CITY OF KIRKLAND
Planning and Building Department
123 5th Avenue, Kirkland, WA 98033
425.587.3600 - www.kirklandwa.gov

MEMORANDUM

Subject: Market Street Dental Clinic (1009 Market Street) Variance Appeal, File No. VAR18-00070

Applicant Submitted Sight Distance Triangles Purportedly Pursuant to City Policy R-13

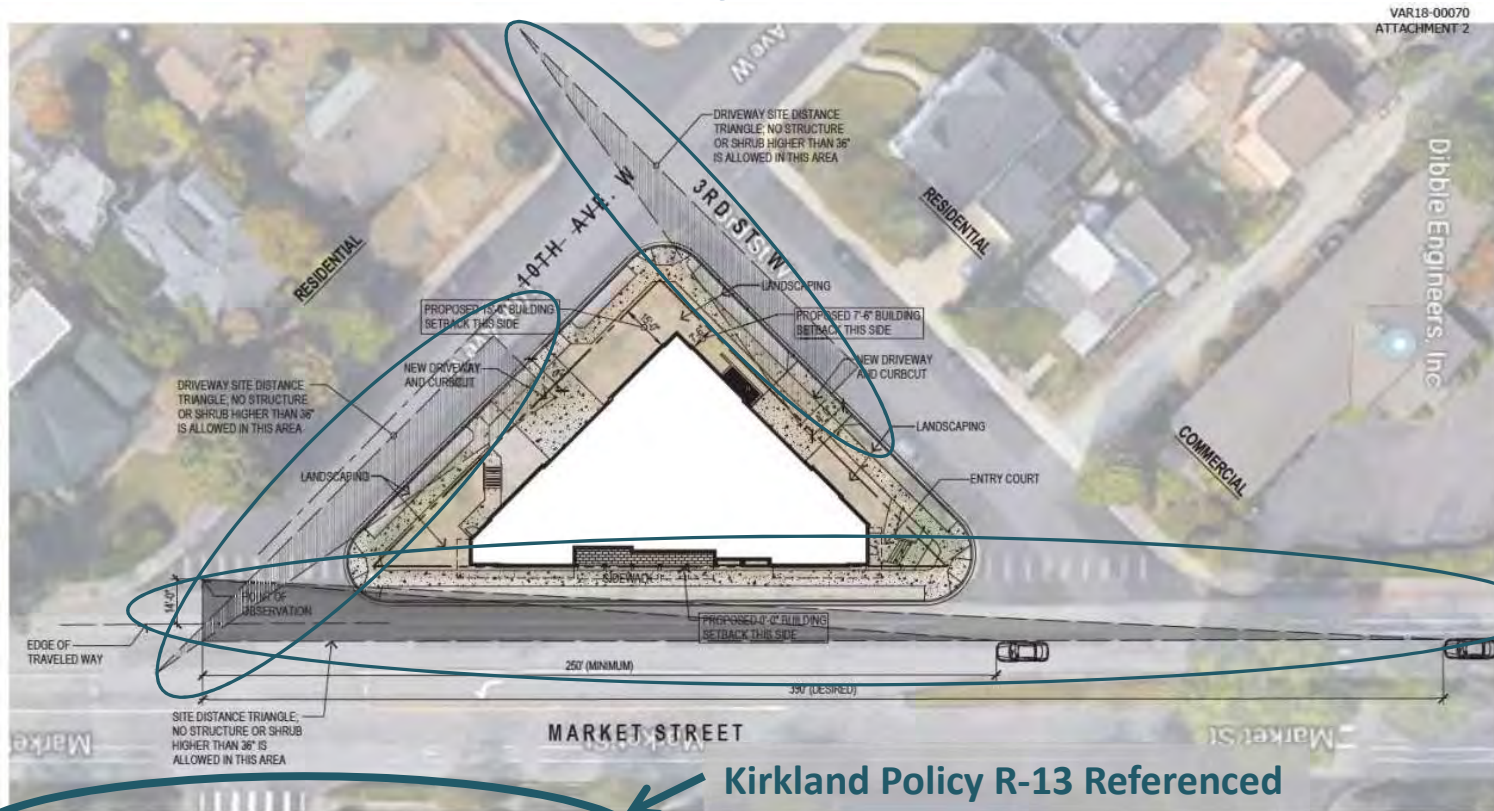
Intersection Challenges

1. Steady Market Street rush hour traffic with rare gaps suitable for crossing or turning
2. Dense: 35 MPH slowing to 25 MPH a few blocks downhill
 - Compression of space between cars
 - Makes judging speed truly difficult
 - On dark or rainy days, just see headlights
 - Bike riders nearly invisible in front of the auto headlight parade
- Cited as a safety problem in multiple public comment letters

Incorrect "Edge of Travelled Way"

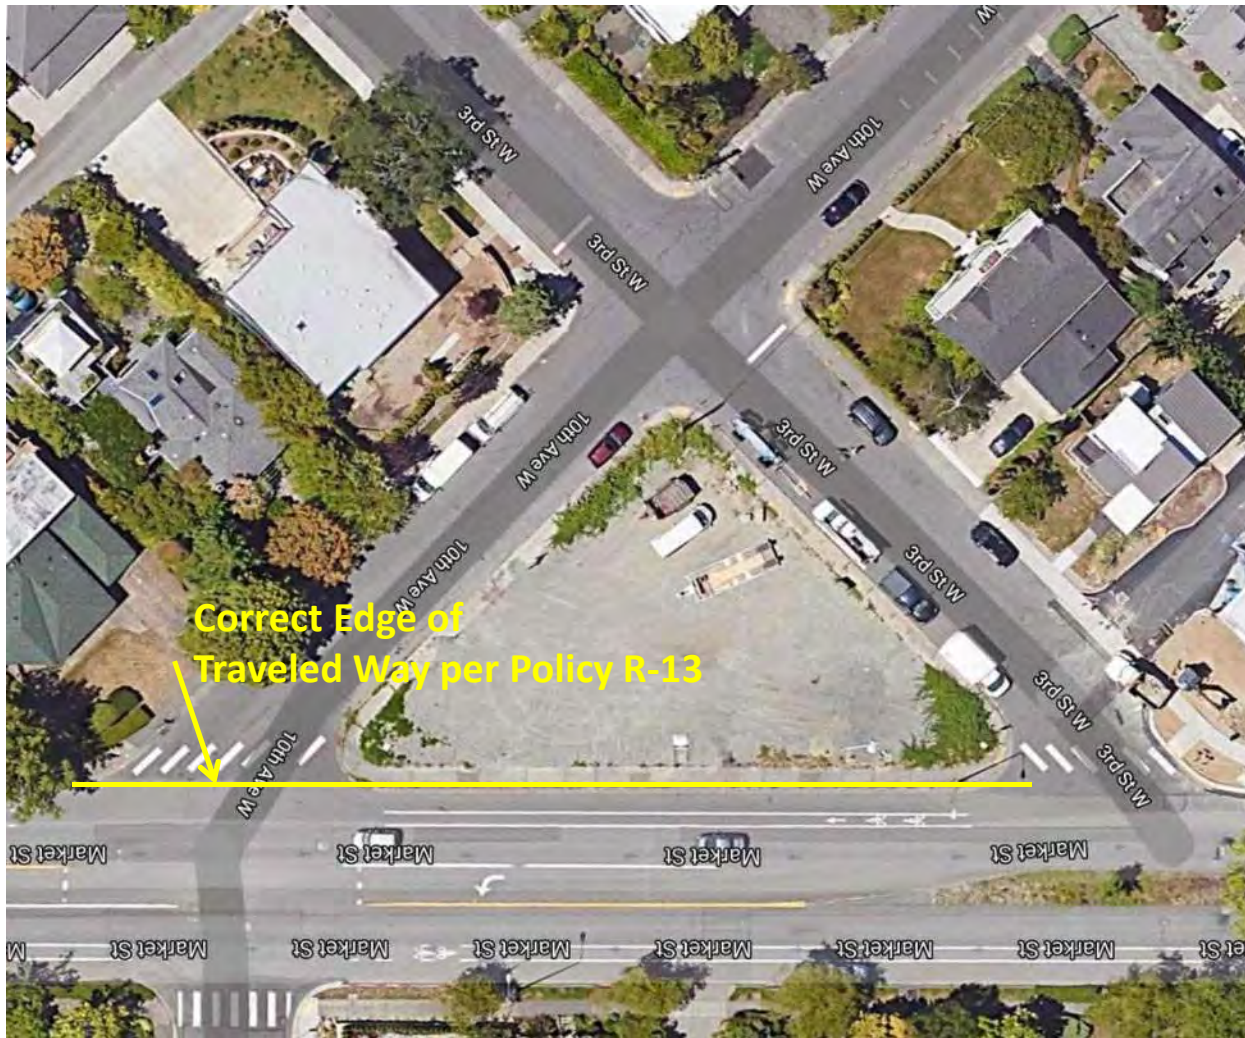
Incorrect "Decision Point"

Incorrect “Sight Distance Triangle”

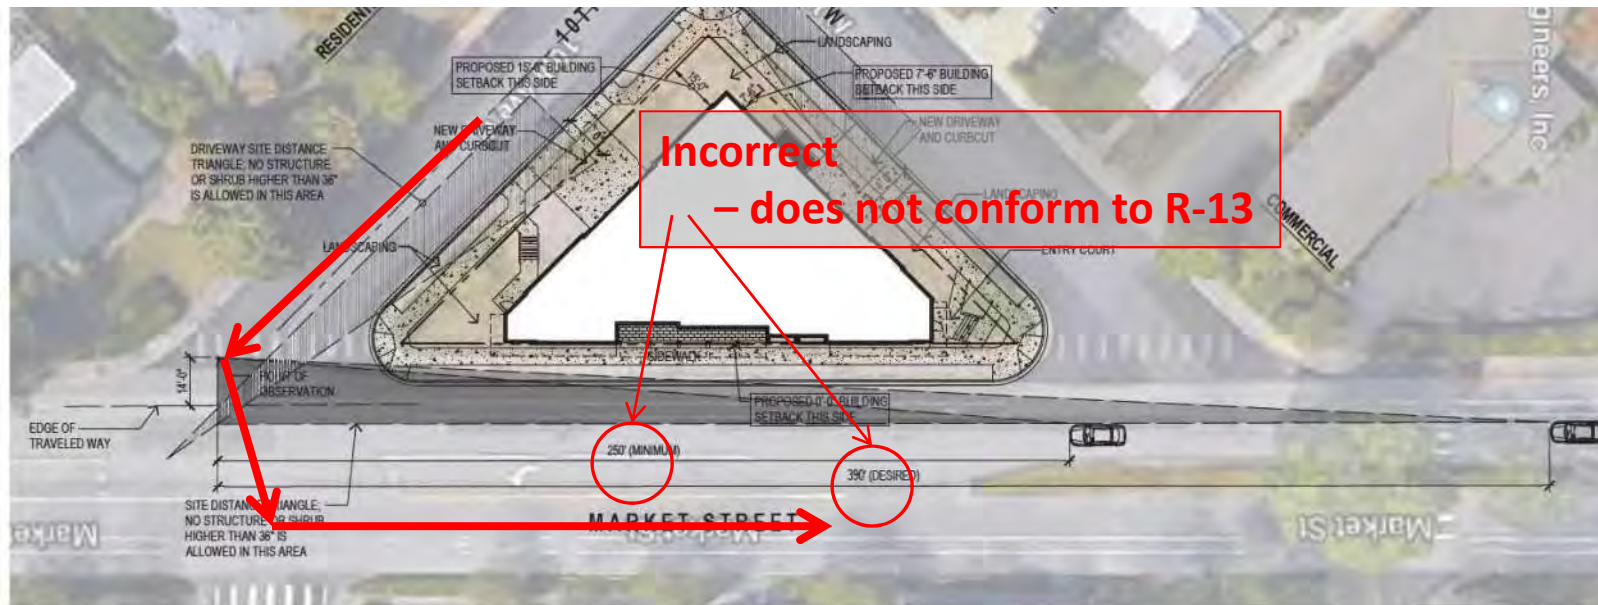
- No sight distance allowance/increase for this “skewed intersection”
- Note especially complicated left turn to northbound Market St

Figure 2. Point of Sight Distance Measurement

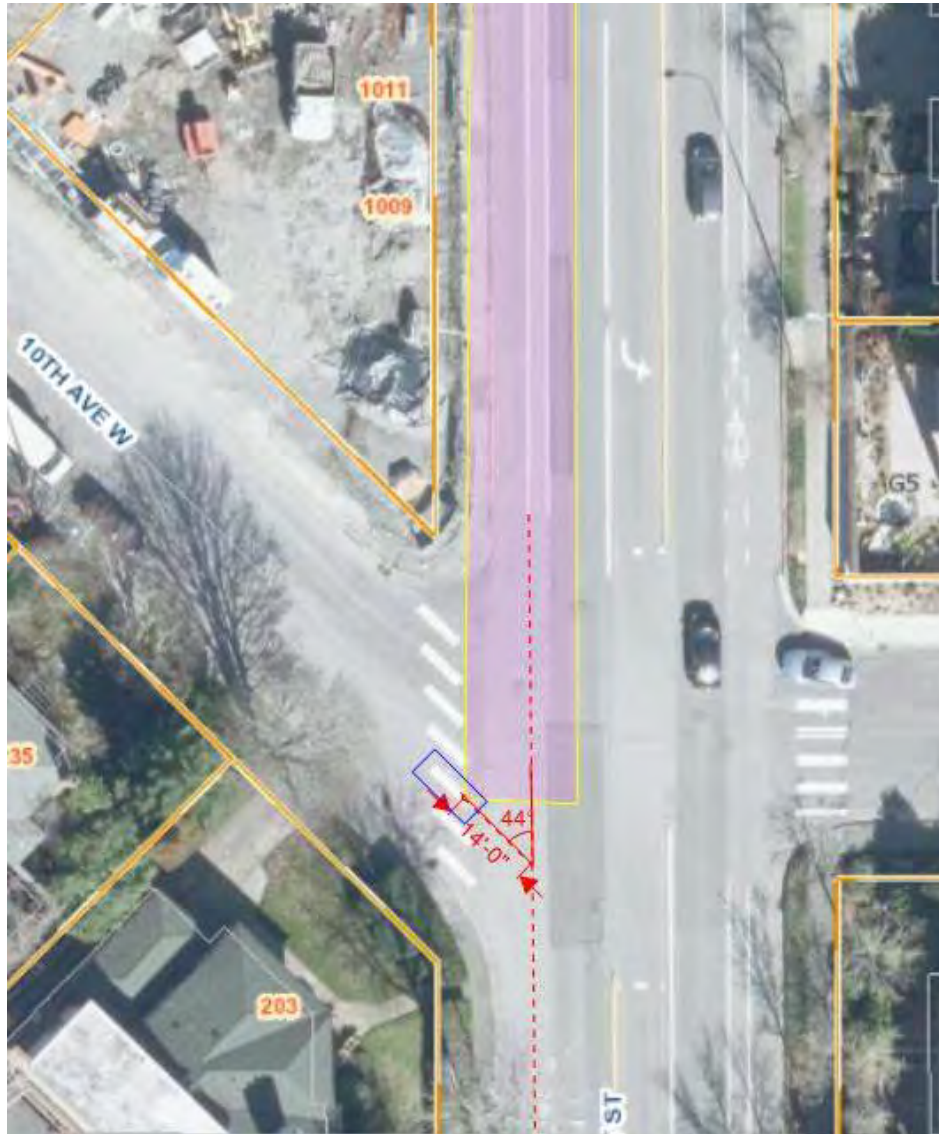
The measured sight distance at this intersection of Market Street/10th Avenue West is over 500 feet, which exceeds the required minimum sight distance of 275 feet. Realistically, there is approximately another eight feet from the point of measurement for a driver to move forward to increase the sight distance without encroaching into the travel lane.

As shown in Figure 2, the sight distance triangle is outside of the property line. Therefore, the awning of the proposed building will not obstruct the sight distance at the intersection of Market Street/10th Avenue West. Furthermore, on-street parking on Market Street is prohibited within 70 feet of the intersection of Market and 10th Avenue

Figure 4. Sight Distance

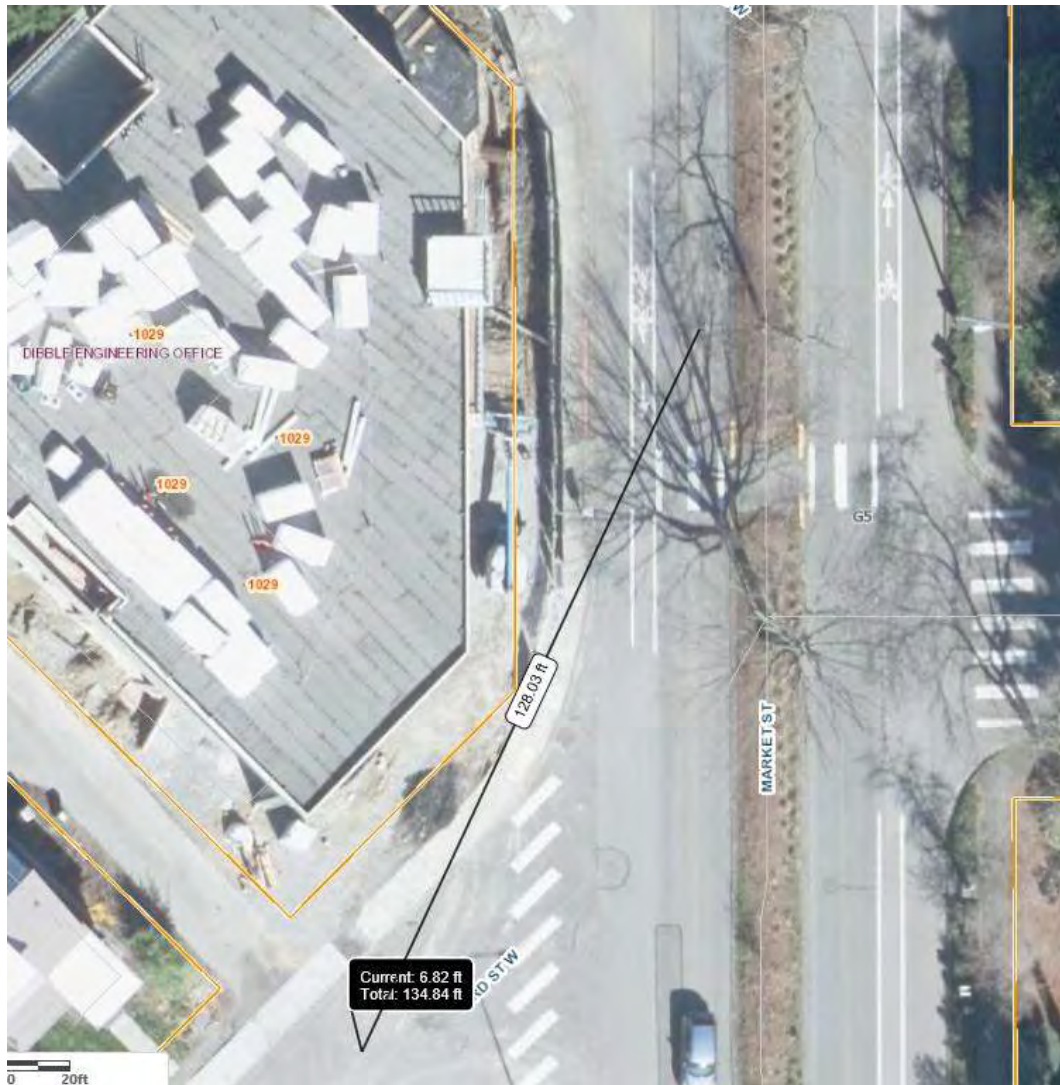
Figure 4 shows the sight distance needed for two vehicles stopping on 3rd Street West. The stopping sight distance is 128 feet, which meets the required stopping sight distance for the 3rd Street West.
